**Re: Western Sydney Stadium (Concept & Stage 1 Demolition), 11 - 13
O'Connell Street, Parramatta NSW 2151**

The Council's submission forms two parts, this letter which serves as an executive summary and our detailed comments by discipline provided as an attachment.

Figure 1 – Day time temperature measured during a heat wave in 2013

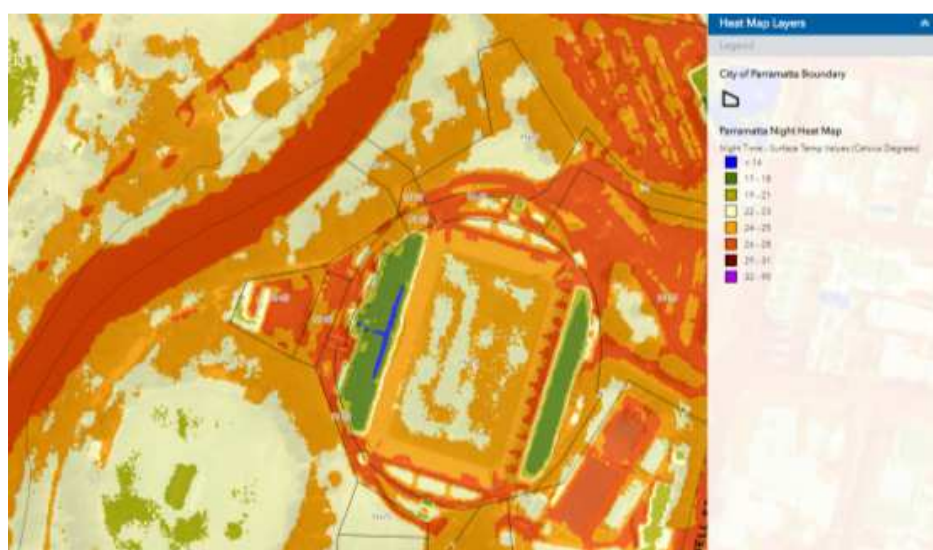
As indicated on Figure 1, below, localised warming occurs between hard infrastructure, such as former Stadium, compared to green spaces and the Parramatta River. Building materials absorb heat, causing surface and ambient temperatures to rise. As Figure 2 shows, the temperature is often greatest at night, when concrete, asphalt and buildings release heat that was absorbed during the day back into the surrounding environment.

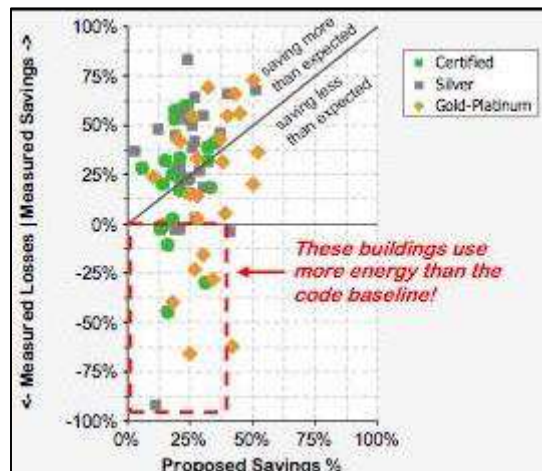
LEED certification is not able to be achieved prior to Occupancy. It is therefore problematic when relied upon in any consent condition. A Pre-certification is offered by the USGBC that provides some independent assurance of application prior to practical completion.

Whilst the report outlines the design initiatives that are to be included in the proposed Western Sydney Stadium, the tracking sheet reveals a high degree of uncertainty and a lack of knowledge of actual design intent suggesting that the

The above diagram shows that measured performance in LEED certified Gold buildings can be significantly worse than minimum code requirements even when significant savings were proposed.² Whilst this study predates LEED v4, the reliance on ASHRAE remains unchanged. The weakness of LEED with respect to energy efficiency requires that a supplementary requirement be added.
